Model: TM80/TM100

Product Bulletin # TM-034 Rev 1

Transducer Upgrade Kit

Figure 3: New transducer mount design as shown

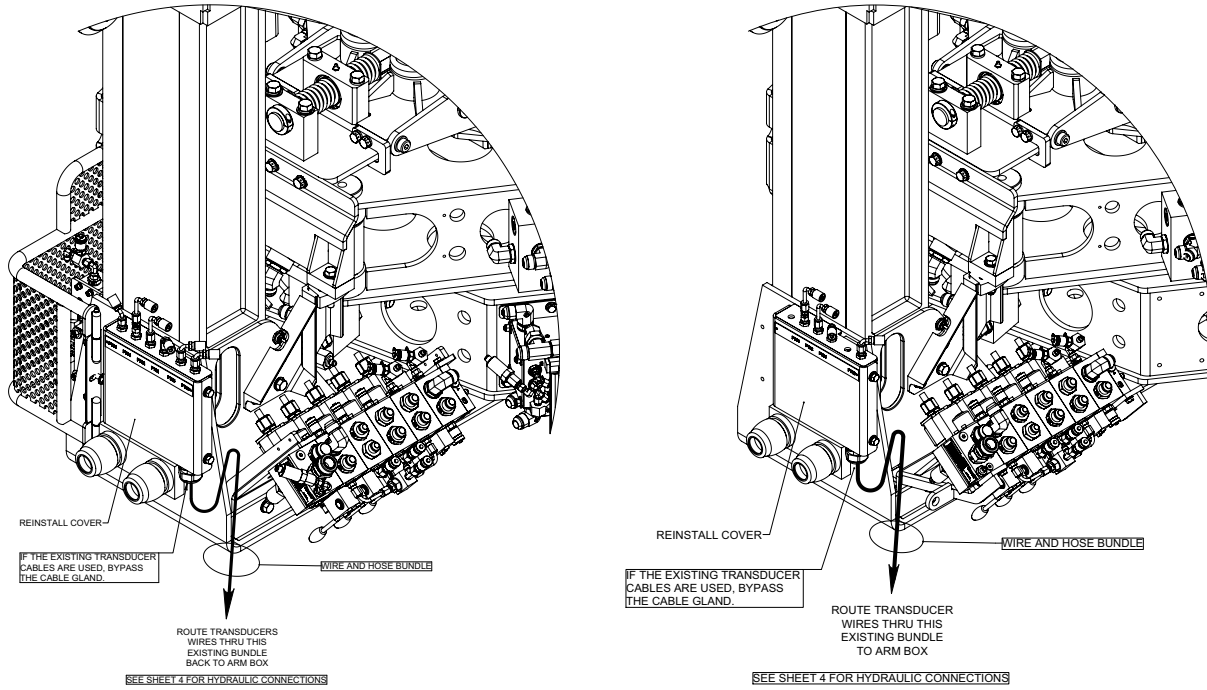
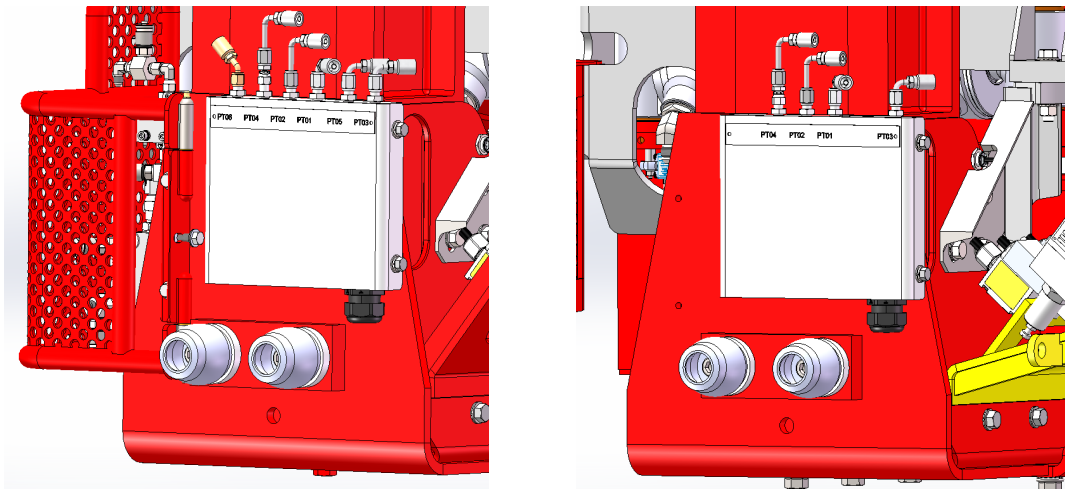
On certain Canrig Torq-Matic™ Wrenches, the transducer assembly mounting hardware is susceptible to vibration-induced failures, leading to potential damages. To address this issue, we have developed a new mounting mechanism designed to support transducers vertically, for both 3,000 psi and 5,000 psi versions, consolidating them into a centralized location. This mount is aimed at markedly reducing failure rates and mitigating damage risks in the event of mounting hardware failure.

2. Remove connections from the transducers. Remove the existing mount from the frame.
3. If unit is already equipped with item 7, it will be 1/2" thick. Use item 5 as a 1/2" spacer. If item 7 needs to be installed, it is 1" thick so item 5 is no longer needed.
4. Install the new mount using hardware provided.
5. Reconnect hoses to the transducers and remove LOTO.

If you decide to install the revised transducer mount on Wrench models TM80/100, order the kit (Canrig P/N: AY52417 for 3,000 psi or Canrig P/N: AY25954 for 5,000 psi) including the new mount and required mounting hardware.
